CITY OF RANCHO PALOS VERDES
COMMUNITY DEVELOPMENT DEPARTMENT RESTROOM ADA COMPLIANCE
30940 HAWTHORNE BLVD.
RANCHO PALOS VERDES, CA 90275

PROJECT NO. 20080019.00
SCALE 1/2" = 1'-0"
DATE 9/29/10
DESIGNED BY DAVID HOPKINS
DRAWN BY STEVE HOPKINS
CHECKED BY DAVID HOPKINS
SHEET NO. A2
2 OF 4 SHTS

1 PROPOSED FLOOR PLAN
SCALE 1/2" = 1'-0"

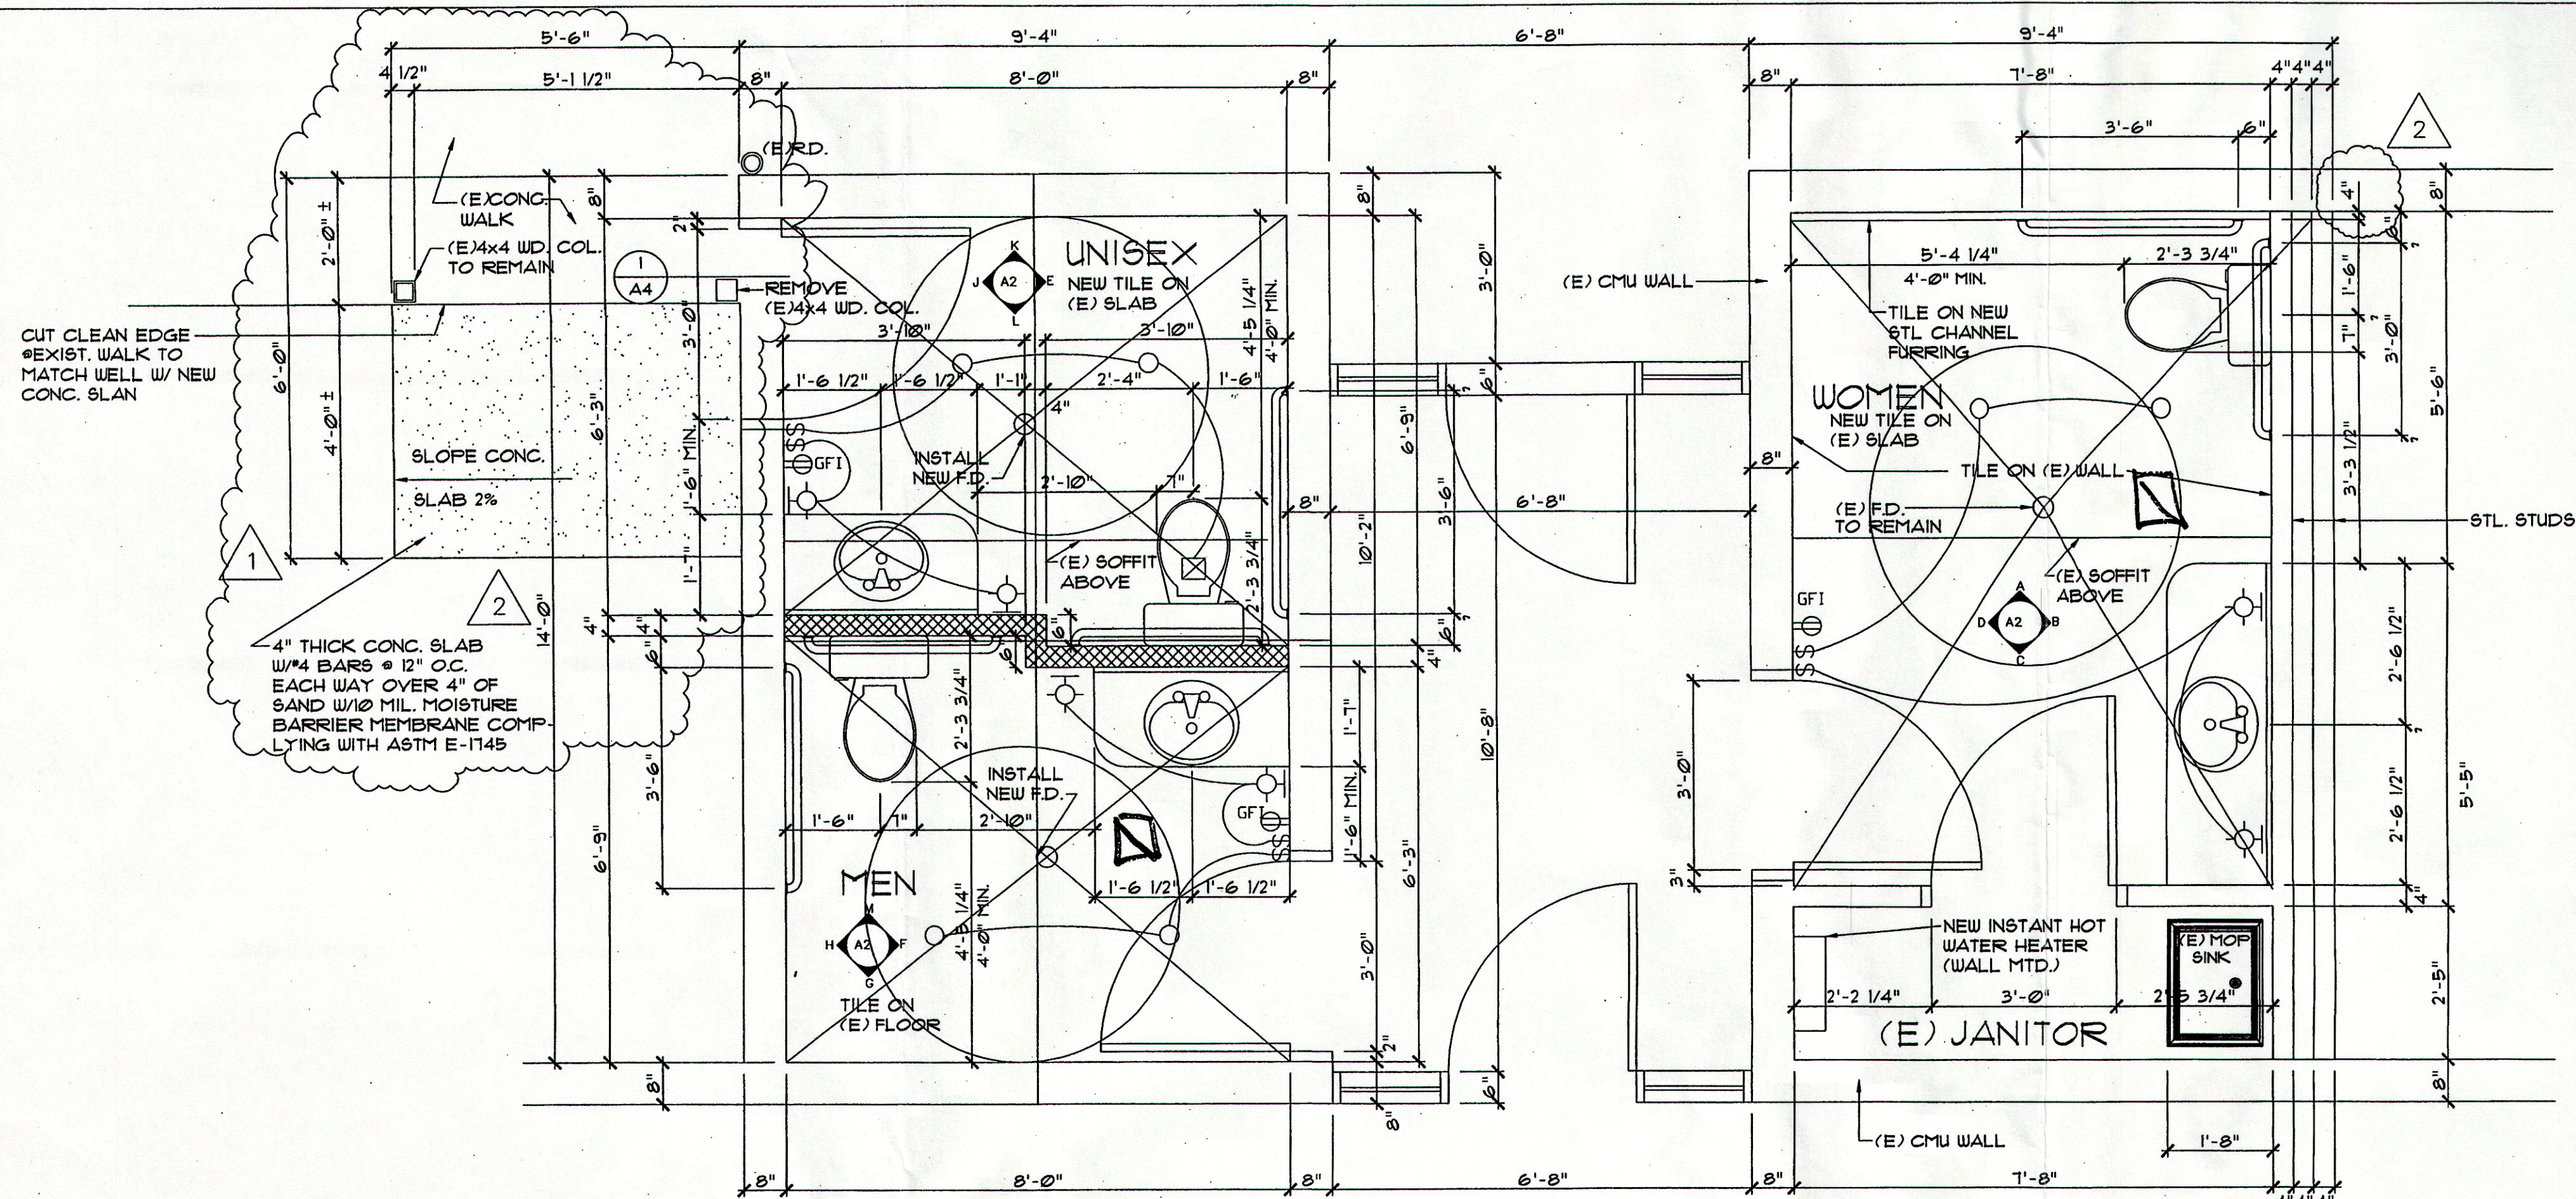
Fluor Drains to have
TRAP Pairs
